Supplemental Information

This Document Errata reflects changes made on the datasheet for device 854S006I.

Errata Items

BLOCK DIAGRAM

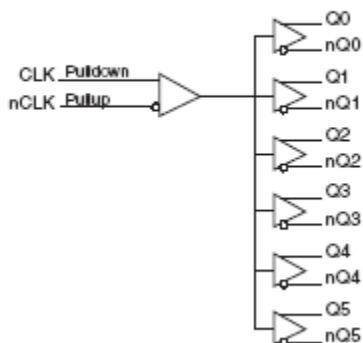
Page 1	Block Diagram. Update Pullup and Pulldown of CLK and nCLK on the block diagram
--------	---
